Access Compliance Report Public Rights-of-Way (Curb Ramps)

Main Street: ANDAZA_ST		Cross Street: ANDAZA_ST		Location:	W
ADA ID: RPAT220125120046	Ramp Type:Type 1 - Perpendicular	Initial Pass/Fail: Fail	Overall Compliance: No	Severity Score:	15

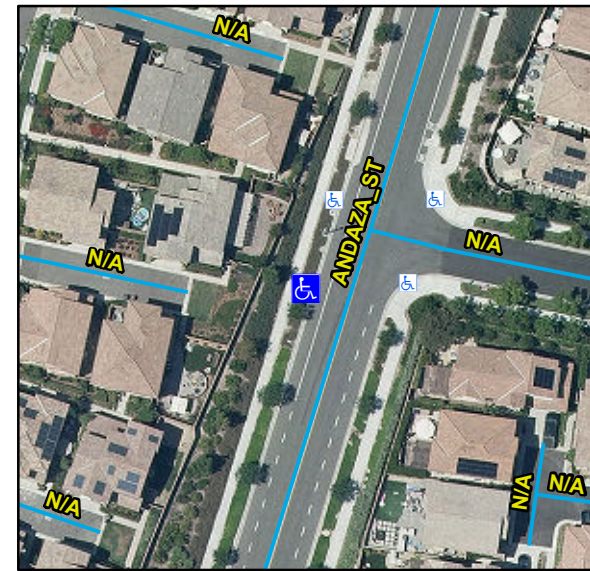
Compliance	Description	Data	Compliance	Description	Data
N/A	Ramp Length (in)	60	N/A	Flare Type LT	
Yes	Ramp Width (in)	60			N/A
No	Ramp Run Slope (%)	9.2	N/A	Flare Slope LT (%)	N/A
Yes	Ramp Cross Slope (%)	3.2	N/A	Flare Traversable LT	N/A
N/A	Landing Present	N/A	N/A	Flare Type RT	
N/A	Landing Length (in)	N/A			N/A
N/A	Landing Width (in)	N/A	N/A	Flare Slope RT (%)	N/A
N/A	Landing Run Slope (%)	N/A	N/A	Flare Traversable RT	N/A
N/A	Landing Cross Slope (%)	N/A	N/A	DWS Provided	N/A
N/A	Landing Movement Obstructed?	N/A	N/A	DWS Contrast	N/A
	Landing Movement Type	N/A	N/A	DWS Length (in)	N/A
N/A	Landing Shared	N/A	N/A	DWS Full Width	N/A
N/A	Clear Space	N/A	N/A	DWS Offset Left (in)	N/A
N/A	Clear Space To Crosswalk (in)	N/A	N/A	DWS Offset Right (in)	N/A
N/A	Marked Crosswalk 1	No	N/A	Marked Crosswalk 2	N/A
	Crossing 1 Direction	SE		Crossing 2 Direction	N/A
	Marked Crosswalk 1 Width (in)	N/A		Marked Crosswalk 2 Width (in)	N/A

N/A	Ramp Inside Crosswalk 1	N/A	Yes	Ramp Inside Crosswalk 2	N/A
	Crossing 1 Slope (%)	3.5		Crossing 2 Slope (%)	N/A
	Crossing 1 Cross Slope (%)	5.6		Crossing 2 Cross Slope (%)	N/A
N/A	Gutter Ponding	N/A	No	Curb Slope	6.8
Yes	Gutter Lip Height (in)	0		Road Run Slope (%)	N/A
N/A	Gutter Run Slope (%)	N/A		Road Cross Slope (%)	N/A
N/A	Gutter Cross Slope (%)	N/A			
Yes	Overall Surface Condition: Acceptable		Yes	Perp Joint Present	Yes
	Cross Gutter Present?	No		Spandrel Present?	No
	Replace Cross Gutter?	N/A		Replace Spandrel?	N/A

Remove & Replace Entire Ramp.

R304.2.2, STD 1115
